Beacon Hall Archive – Solhaven Annex Design – May 2023

New Proposed Layout

Figure 3: Proposed annex layout

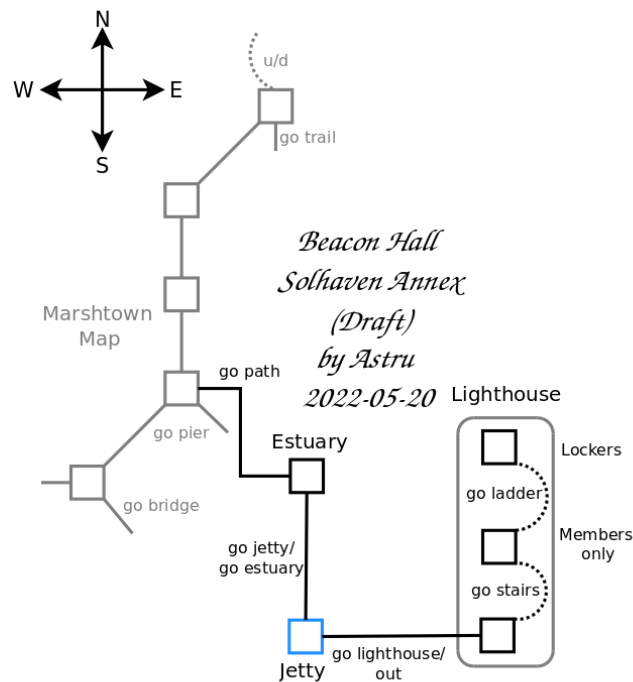
After investigating the area for the room you requested [Marshtown, Land's End], we feel that it doesn't quite fit for there to be a pier extending out from that. This is where the platform portion of Marshtown touches down onto land. If you want to move south of here, there is a pier where the water becomes deep enough.

The building being a lighthouse is fine, but if it's to be at all functional, the location is not a good fit. Where it's proposed is basically near where the Cairnfang River pours down into Solhaven Bay. The ocean itself is more south and west of this Marshtown location. Since a lighthouse is a jutting out point to avoid land, I don't think we'd find a lighthouse here in this area.

The estuary idea is fine, however the sea cave in this area may not be warranted. Marshtown is not really rocky. It's muddy and marshy, with the area built on platforms.

In scanning the area for a better fit for your proposed plans, we didn't really come up with a room better suited around Land's End that hits all your marks. Alternatively, we could have a path leading from that room to the building (lighthouse or otherwise). And then rather than having the estuary in the waters of the marsh/bay, have something that is say north of the building be a pool of water that could be used as a swimming hole. And then beyond that could be a small cave, not necessarily a sea cave, but that would more be where there is solid land to have something like a cave.

This is the revised proposal for a room layout of the annex. The original draft included a sea cave, which was considered unsuitable due to the muddy nature of the ground in Marshtown and we decided to lean into the idea of lighthouse jutting into the bay.

The layout would basically be a path leading to the shore of the estuary from under Langi's dock, then one would proceed onto a jetty that would lead to the lighthouse at the end. The lighthouse would be a tower containing three rooms with the main floor accessible to the public, a members only room on the second floor and the top of the lighthouse would be the lockers.

- Entry is a path leading under Langi's dock to estuary
- Estuary (swimming hole)
- Jetty (fishing pond)
- Lighthouse
 - Main floor: public entry with artifacts (peer from windows)
 - Second floor: Members-only (required before lockers)
 - Top of the Lighthouse: Lockers
